Our Ref: P.1464.21 South Pavenhill Farm, Purton, SN5 4FH

**Addendum LVA letter for Land at South Pavenhill Farm, Purton, Wilts, SN5 4DQ**

Revised Description of Proposed Development: Erection of 60 dwellings, construction of a new vehicular access, landscaping, and associated works.

**Image 2: Updated ZTV (April 2026) shown on amended Figure 2.4 Viewpoint locations plan with ZTV**

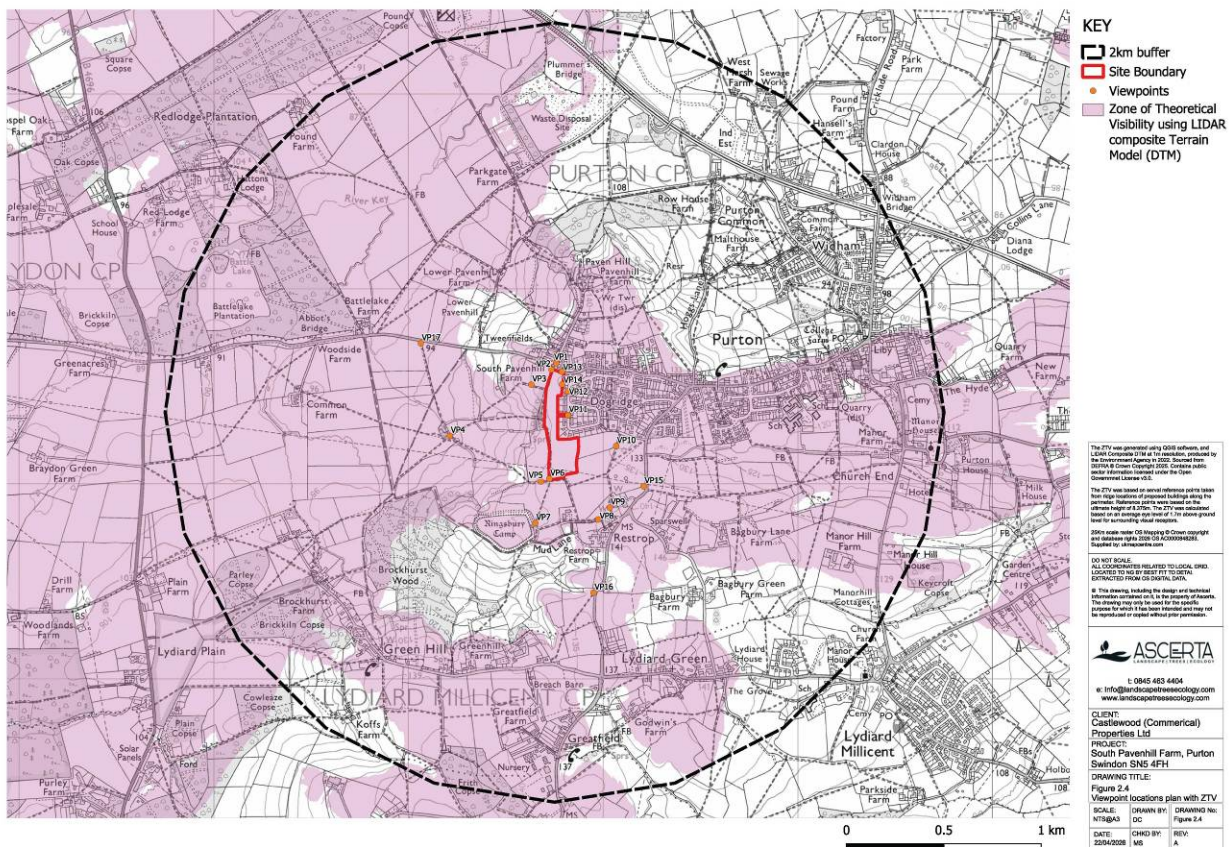
The ZTV has been updated (refer to image 2 below) due to the fact that the ultimate height of the proposed built form is reduced to 8.375m compared to the approximate height of 9m that was referenced to generate the ZTV within the original. The ZTV remains based on a 'bare-earth' / worst-case situation where only topography is considered, no intervening surface factors are considered such as trees, hedgerows, woodland, or built-form. It is worth noting that old ZTV from the original LVA was generated using OS Terrain 5m data at 5m resolution, whilst the new ZTV was generated using different topography data of a higher resolution which was LIDAR composite DTM at 1m resolution by the Environment Agency in 2022.

The extent and shape of the new ZTV appears similar to the previous ZTV with small areas of visibility reduced along the edge of the ZTV. Mainly small areas to the south, south-west, and north of the proposed development within the context of the 2.5km study area. This very minor reduction in zone of visibility is likely due to the small reduction of the ultimate height and potentially the higher resolution of topography data used to generate the ZTV.
